Detailed Contents of US-APWR DCD Revision

June 25, 2008
Mitsubishi Heavy Industries, LTD.

Auxiliary Building
EL 25'-3"

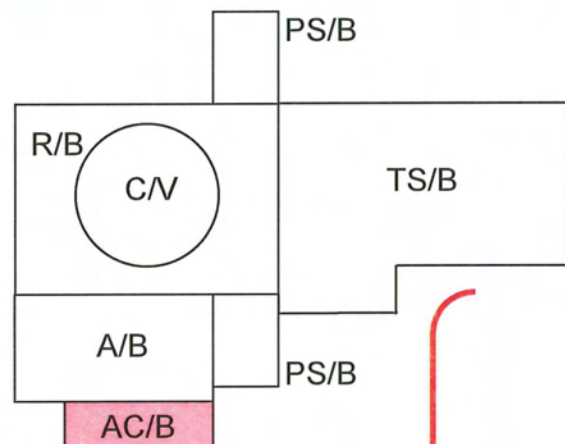
TSC relocated from
Auxiliary Building.

SGBD
Demineralizers
relocated to EL 25'-
3".

10.4.10 Chemical Injection System

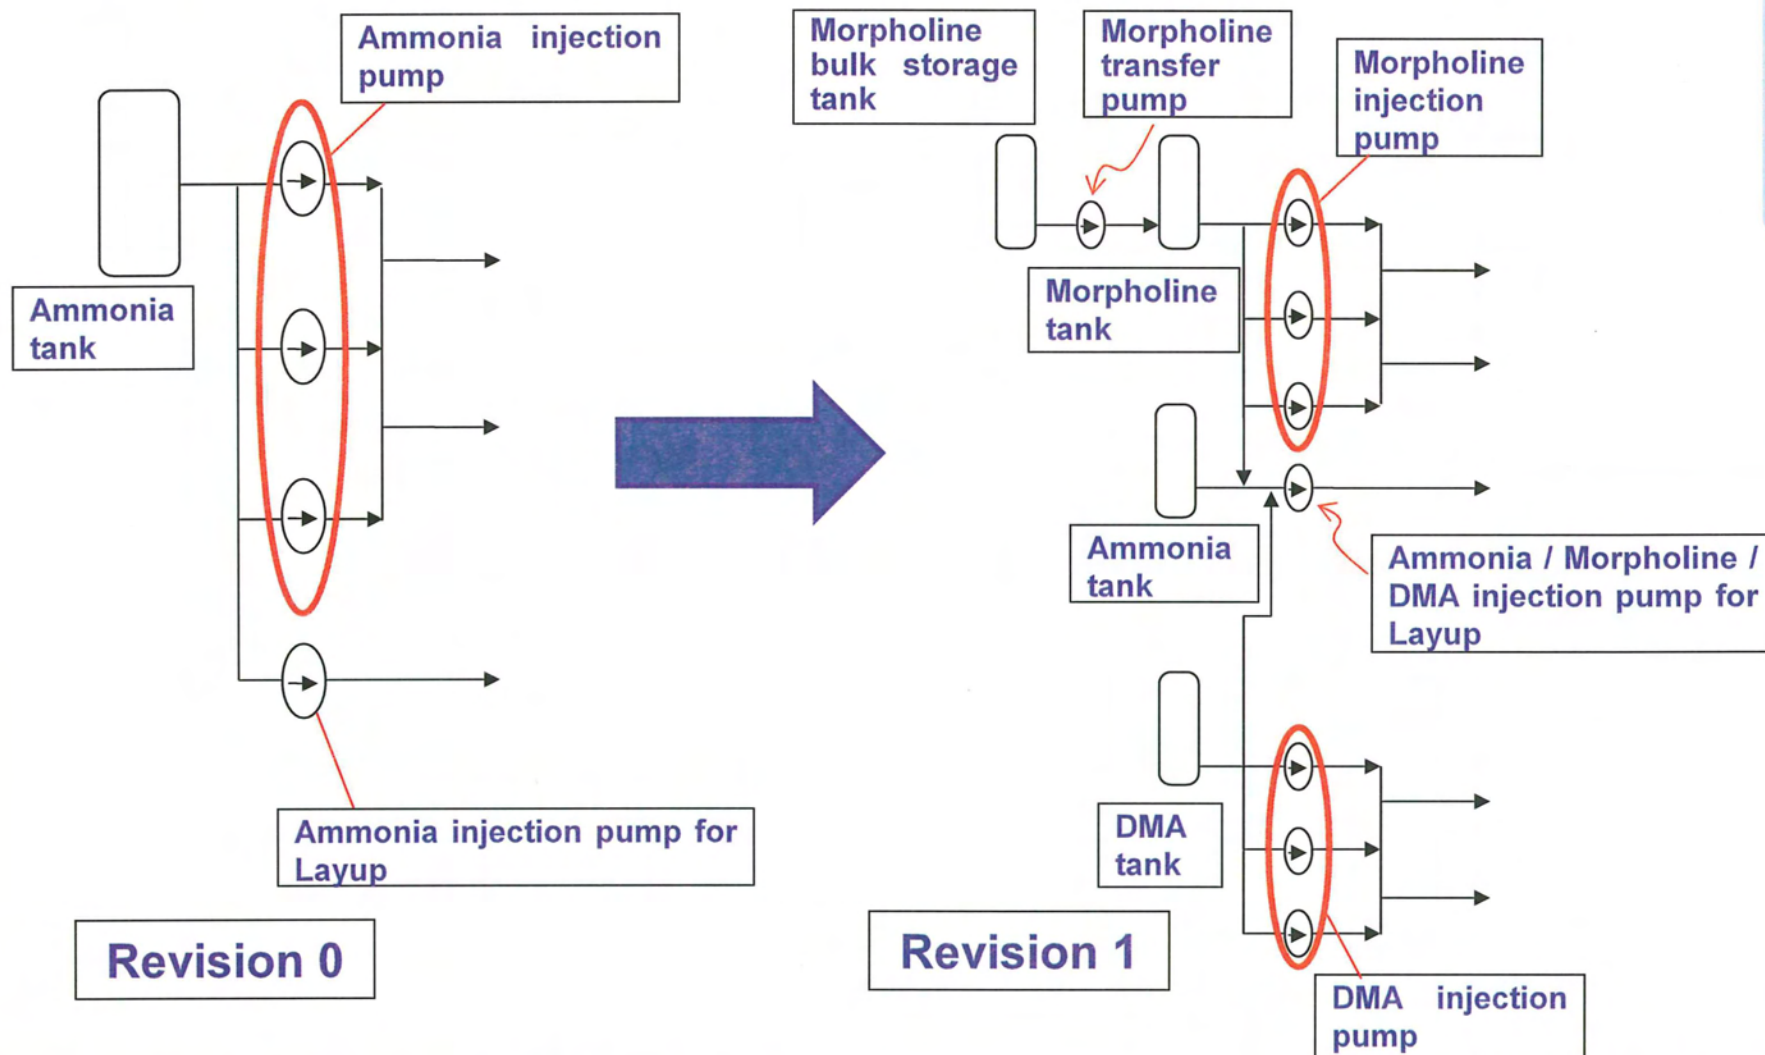
- Change of pH controller from ammonia to **morpholine and DMA**
Addition of components relating morpholine and DMA (chemical tank, injection pump, etc)
- Incorporated bulk chemical system from COL item into standard design
Addition of components relating bulk chemical system (bulk storage tank, transfer pump, etc)

10.4.11 Auxiliary Steam Supply System

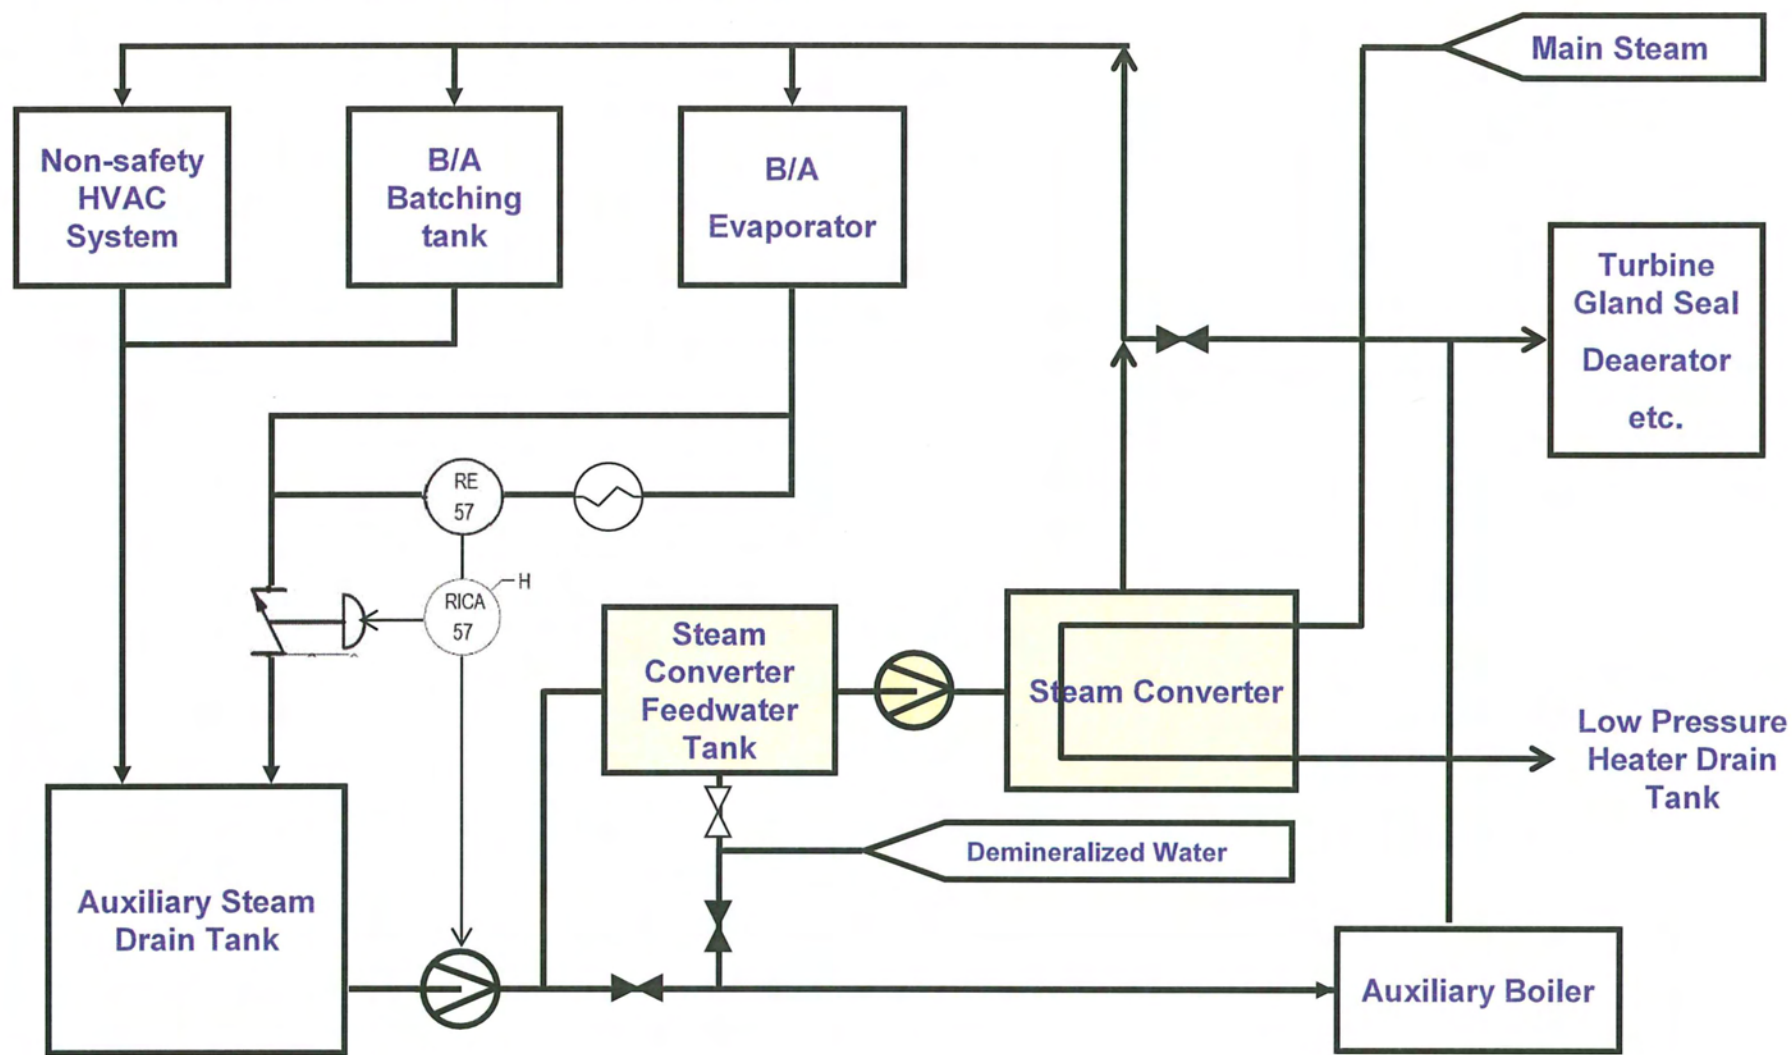
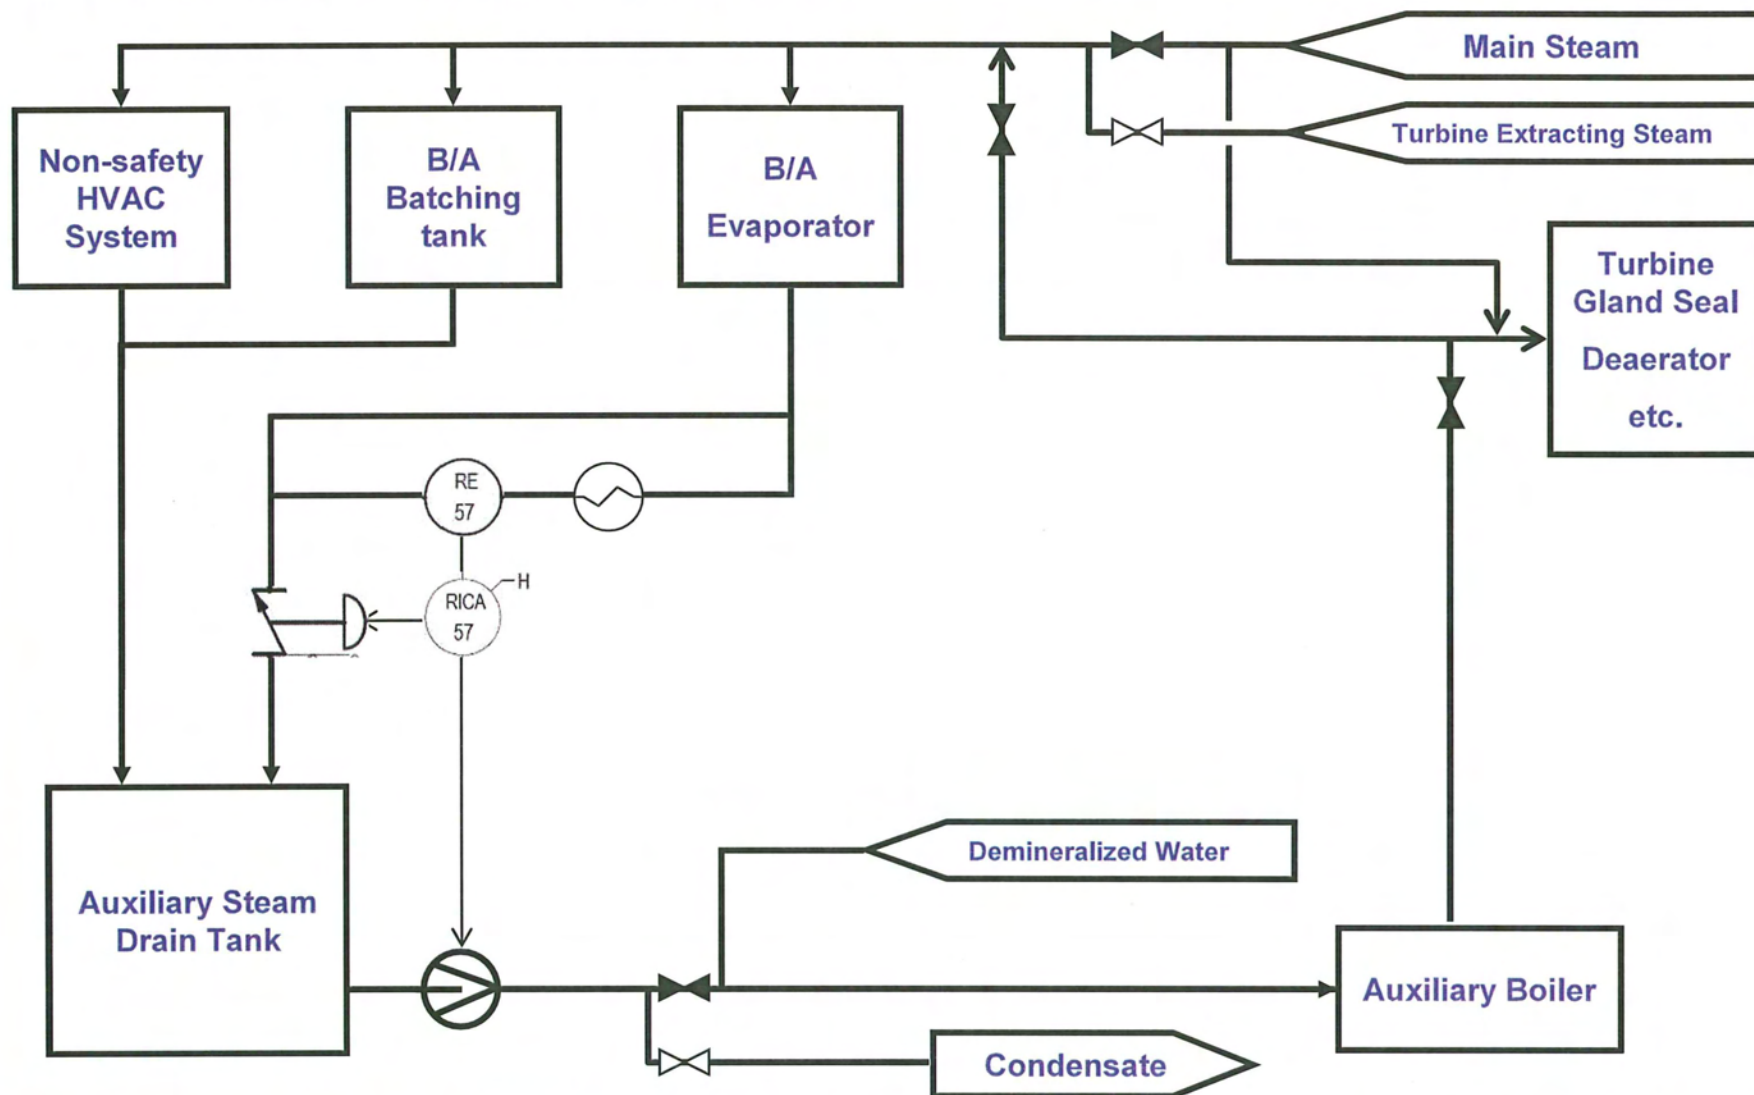
- **Elimination of the steam converter**
- **Elimination of components relating the steam converter elimination (pump, piping, valves, instruments)**
- **Auxiliary steam source change to the main steam or turbine extracting steam**
